Subject: McGuire Nuclear Station  
Docket Nos. 50-369 and 50-370  
Preservice Inspection Plan

Requests For Relief From  
Inservice Inspection Requirement  
McGuire Nuclear Station

ATTACHMENT 2

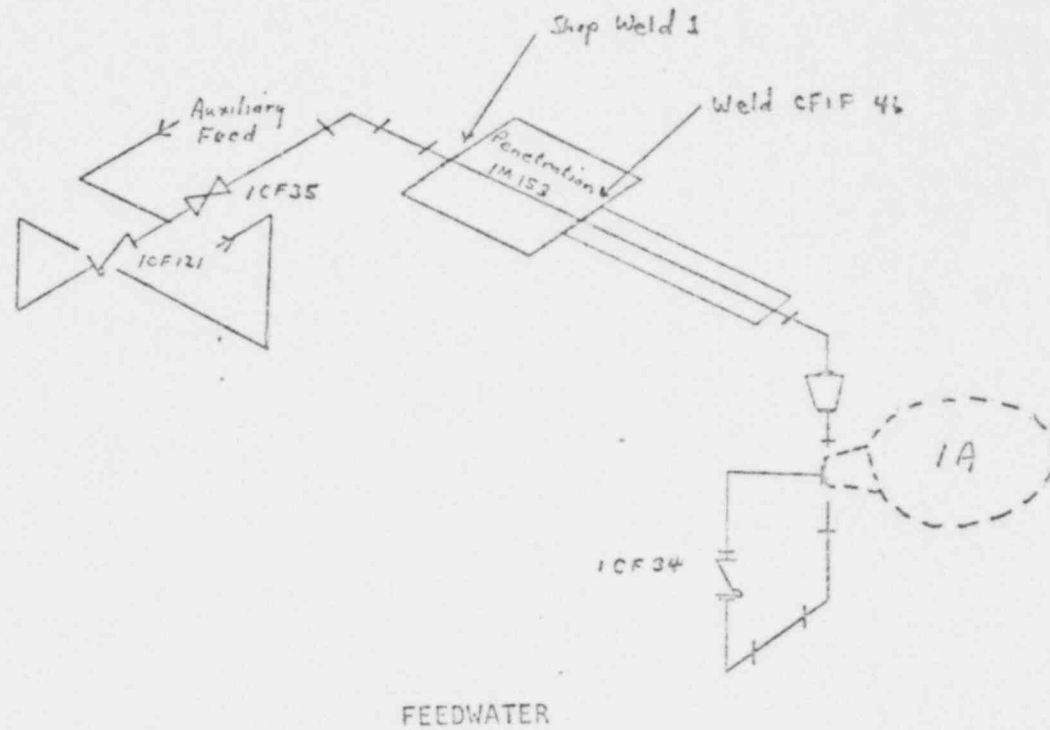
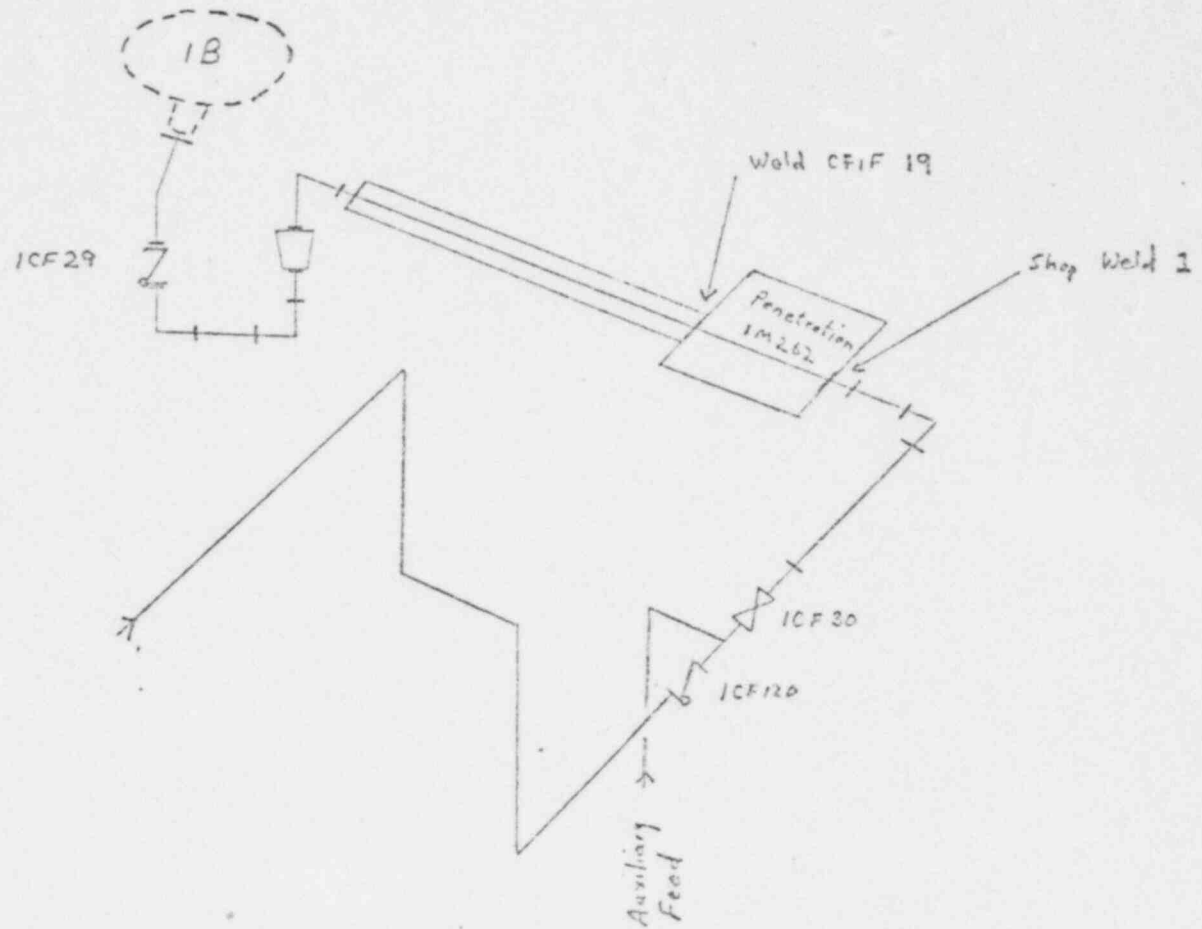
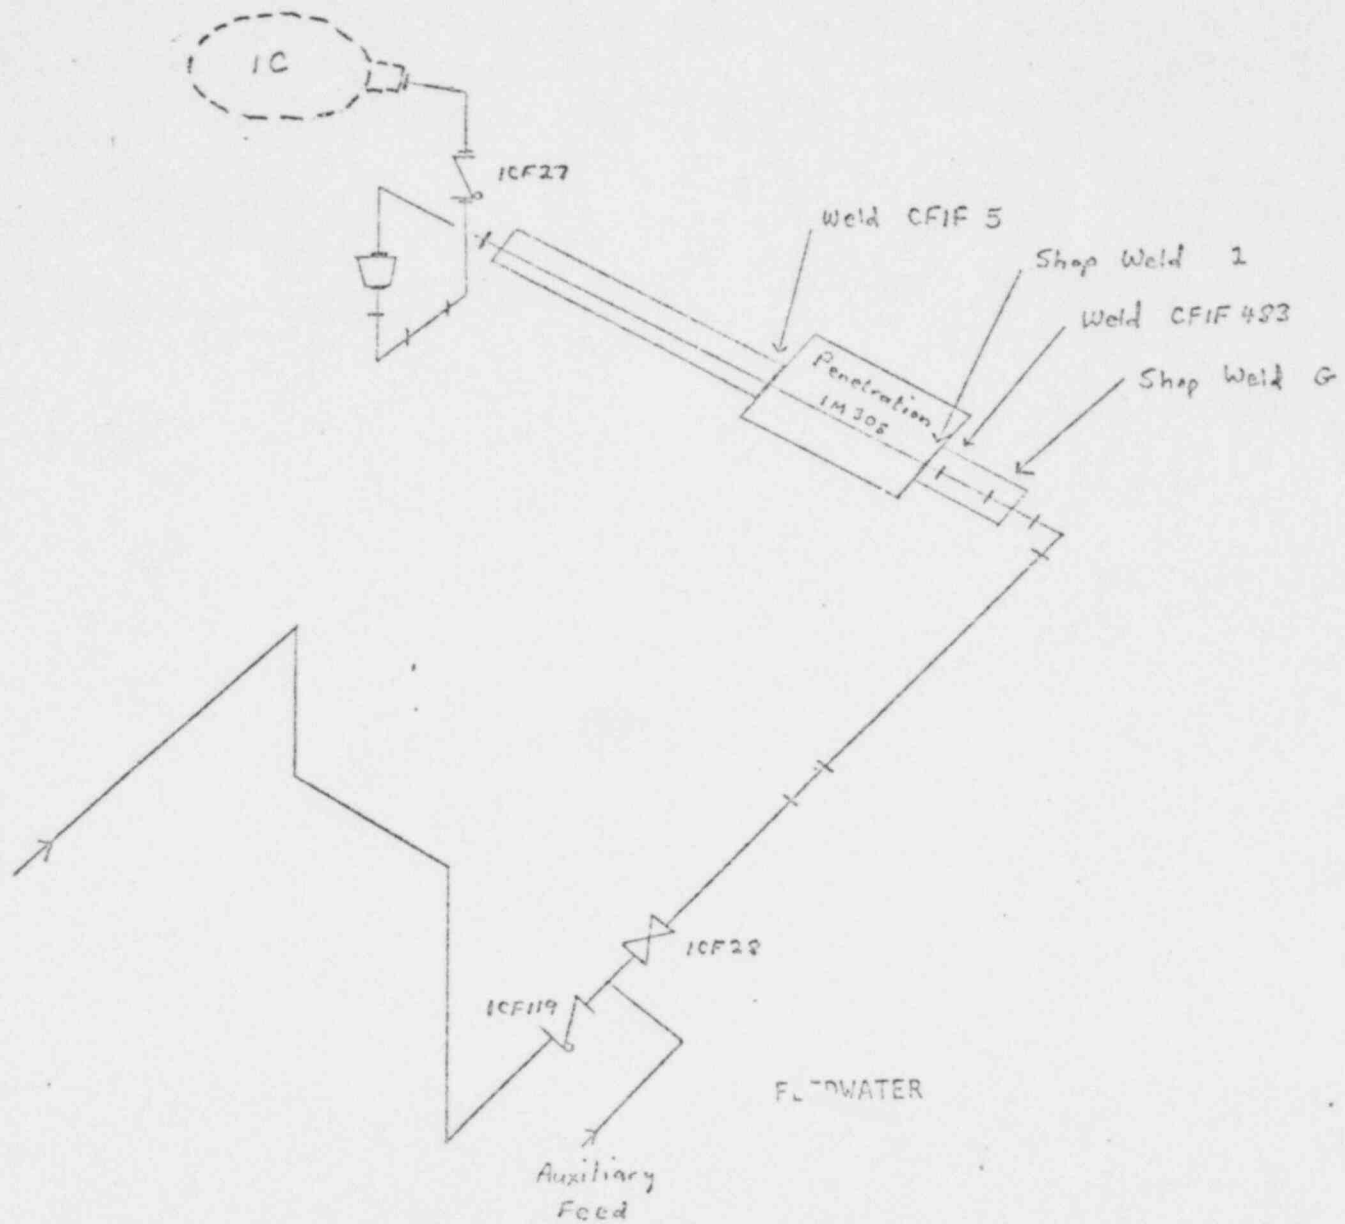
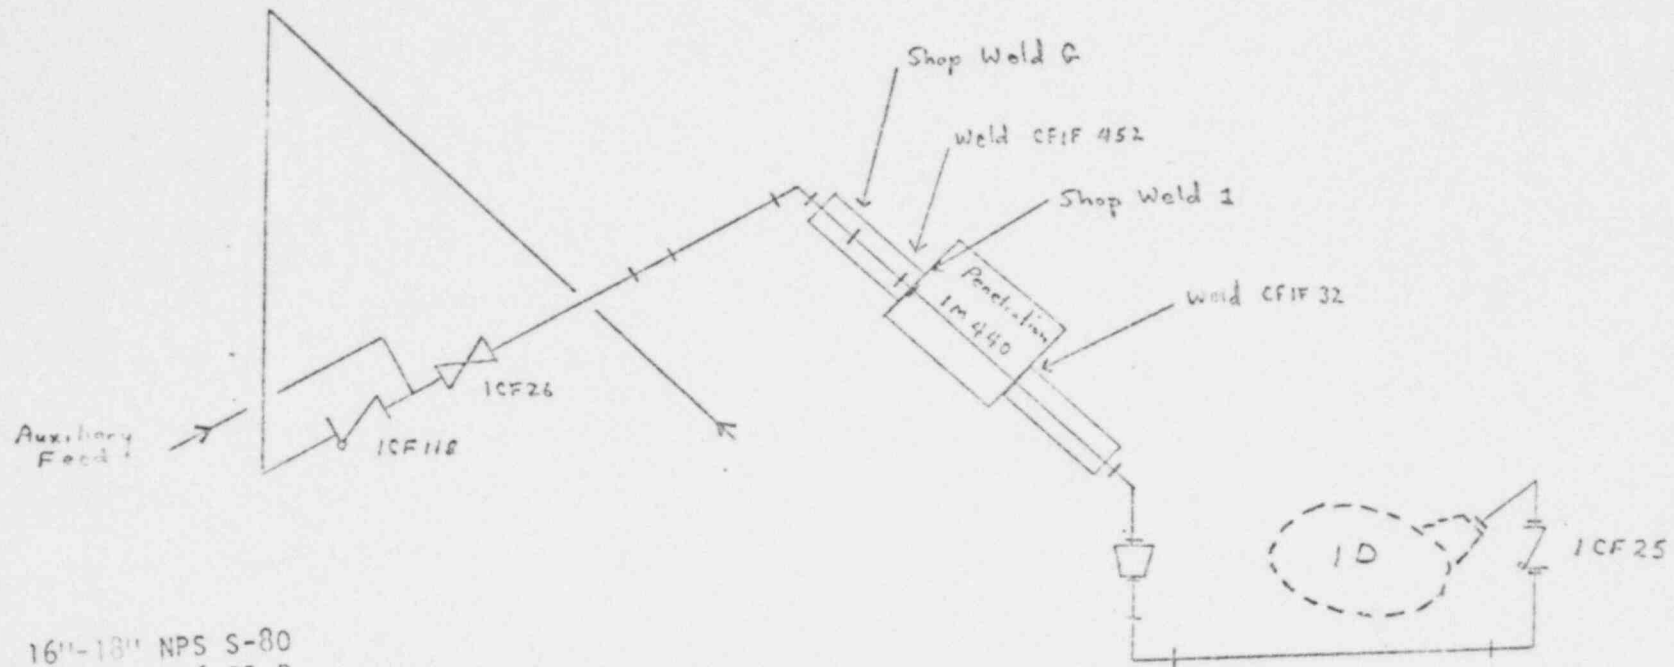
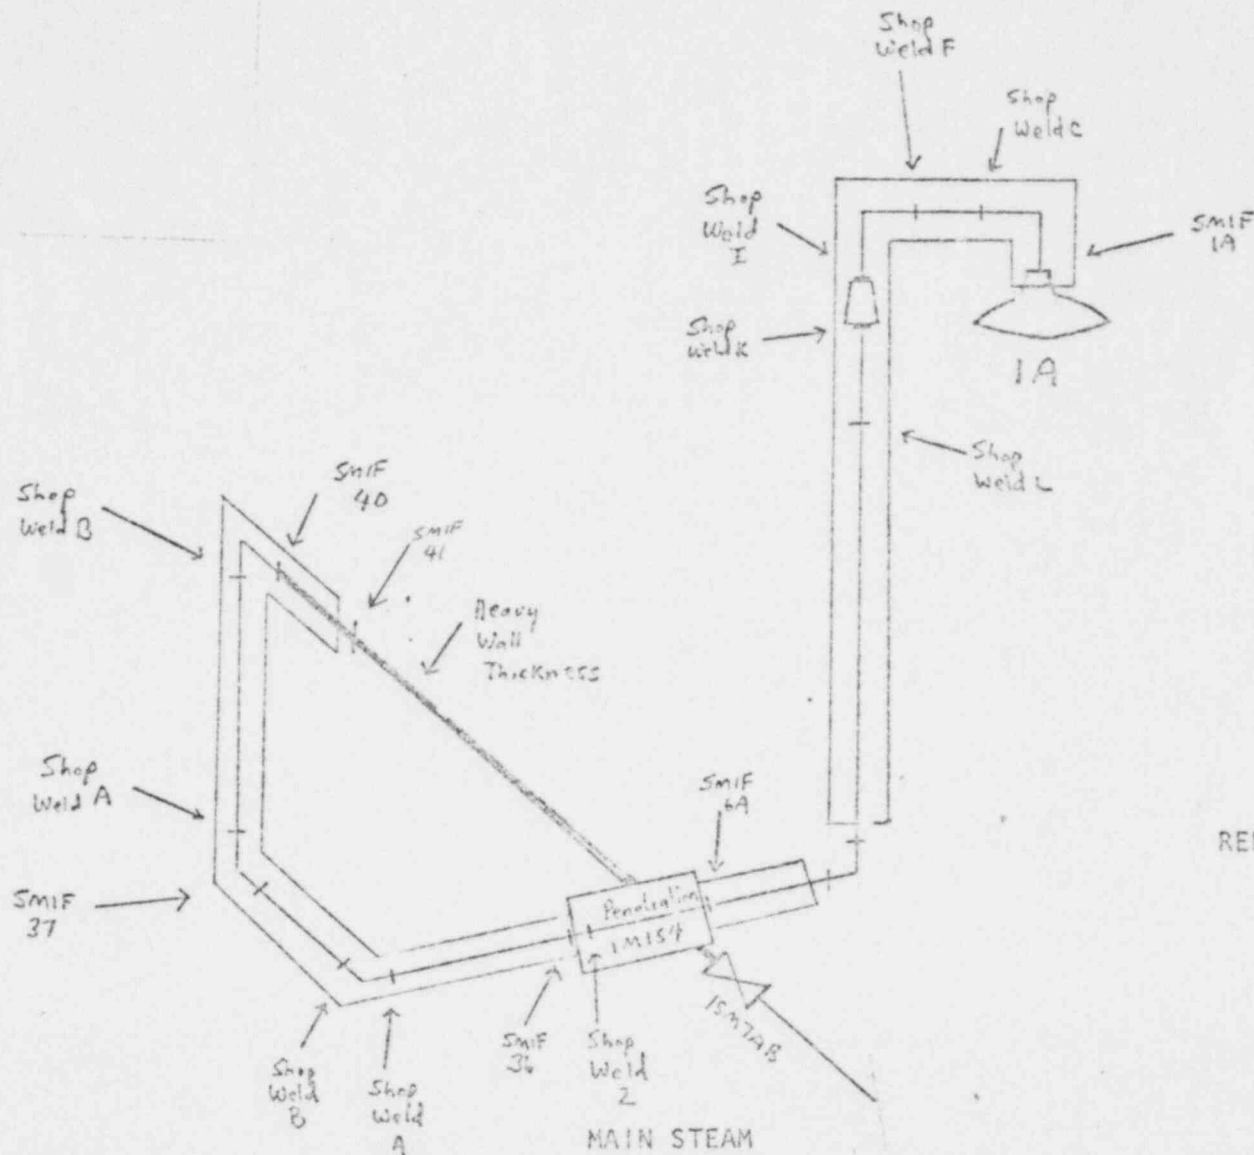
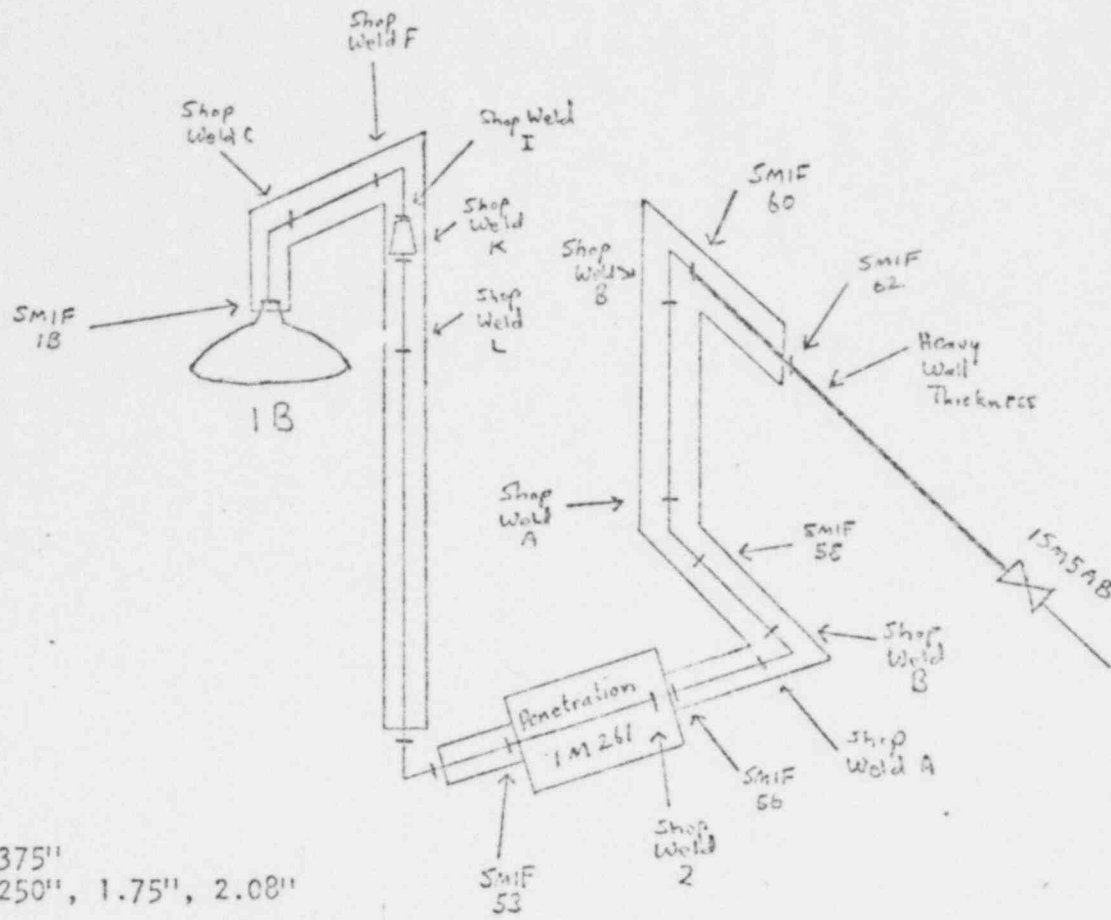
II. Reference Code Requirement that has been determined to be impractical:  
Category CG, Item C2.1 of Table ISC-261, Volumetric Examination of piping  
circumferential butt welds. Due to presence of guard pipe, approximately  
16% of the feedwater and 75% of the Main Steam welds are inaccessible.

- III. Basis for Requesting Relief (cont.)  
The guard pipe was designed and installed for pipe rupture and jet impingement protection required by NRC directives. Section XI requirements to inspect Class II piping systems had not been developed at the time of system design. Component integrity can be assured by examining the accessible welds (Section XI only requires examining 50% of the welds at structural discontinuities, and this number is further reduced by applying the multiple stream concept) and hydrostatic tests. The purpose of the guard pipe and support systems is to maintain plant safety in the unlikely event of system failure. We believe the extreme measures required to make the areas accessible without compensating increase in the level of quality assurance do not justify the high cost and loss of time.
- IV. Alternate Examination:  
No alternate examination is possible.

Preservice examination has been completed on the accessible welds. Inservice examinations will be performed on the accessible welds as required by the Section XI specified by 10CFR50.55a paragraph (g).

Typical Support Arrangements

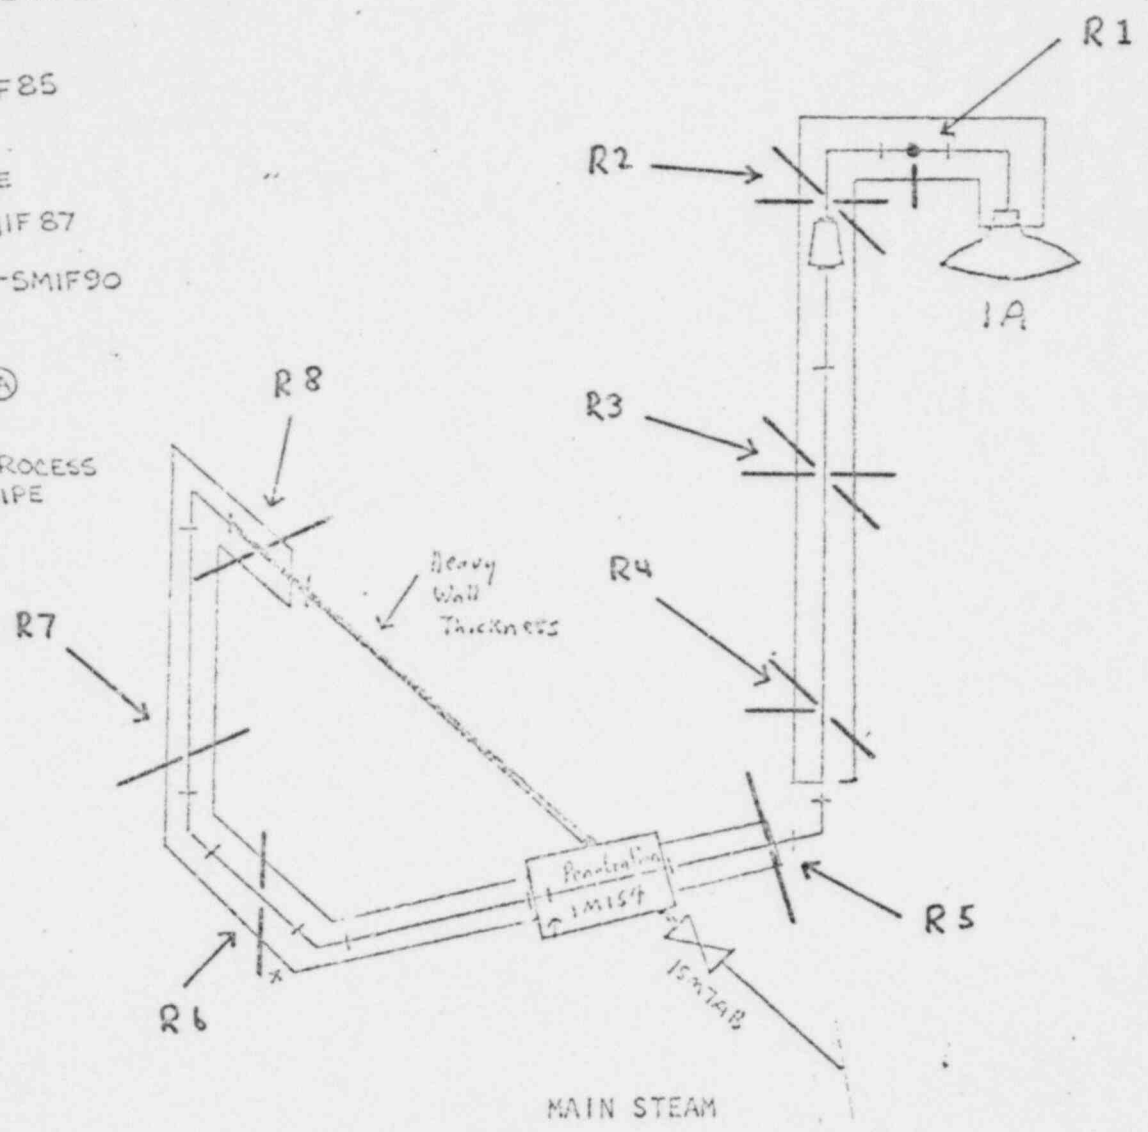
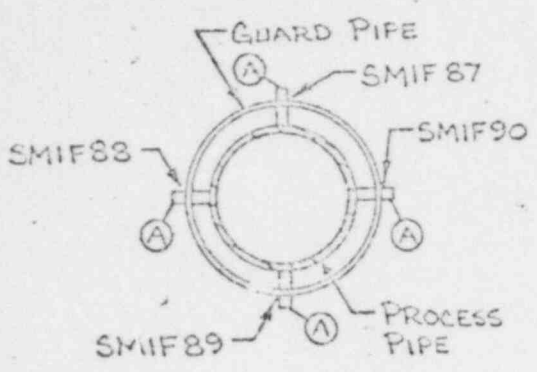
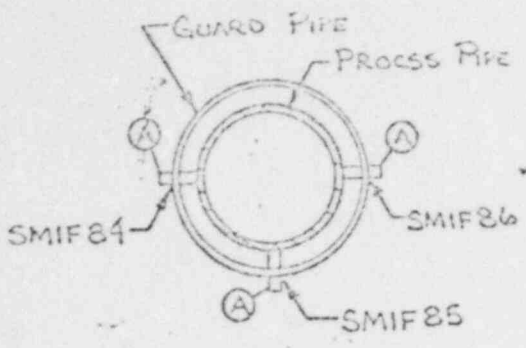
Category C-C, Item C2.4 of Table ISC-261 surface examination of integrally welded support-to-pipe welds. Due to the presence of guard pipe the welded wear pads of 1a above are inaccessible.

The main steam guard pipe was designed and purchased before there was a Section XI requirement to inspect Class II components. These wear pads are only subject to compressive stresses. The welds have been verified defect free by original fabrication examination. Component integrity can be assured by inspecting similar system welds and hydrostatic tests.

The system is installed and field hydrostatically tested. Inservice inspections will not be possible because of inaccessibility.

Feedwater Welded Attachments

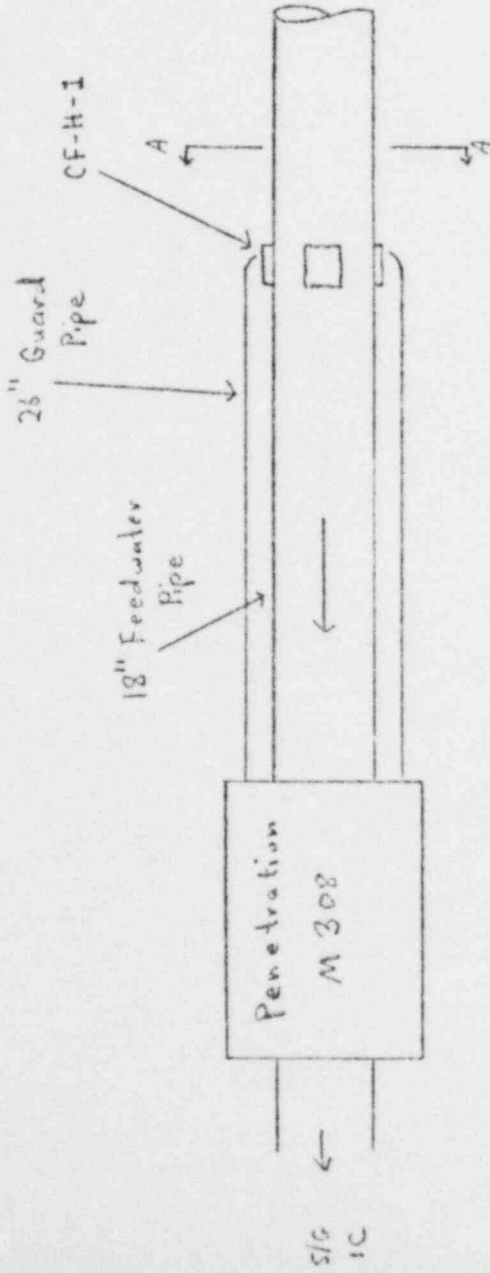
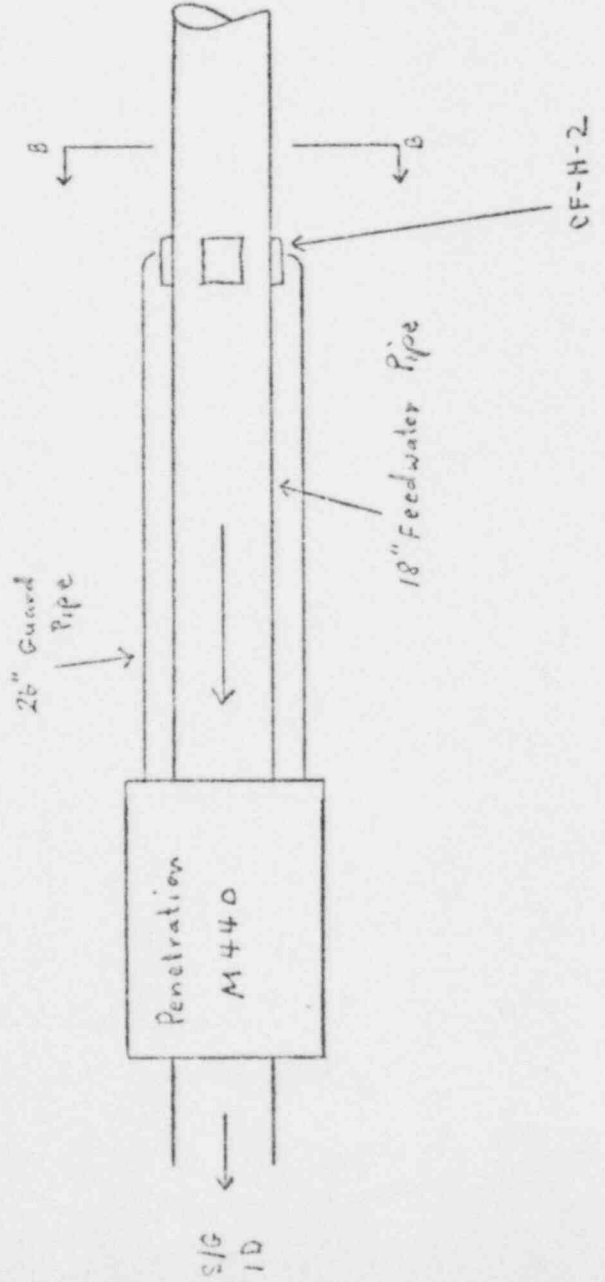
Category C-C, Item C2.4 of Table ISC-261 surface examination of integrally welded support-to-pipe welds. Due to the presence of guard pipe the wear pads are partially inaccessible.

The feedwater guard pipe was designed and purchased before there was a Section XI requirement to inspect Class II components. The welds have been verified defect free by original fabrication examination. Component integrity can be assured by inspecting the 35% of the accessible area, inspection of similar system welds, and hydrostatic tests.

The system is installed and field hydrostatically tested. The accessible areas will be examined in January 1979. Inservice examination of the accessible areas will be in accordance with the Section XI code required by 10CFR50.55a, paragraph g.
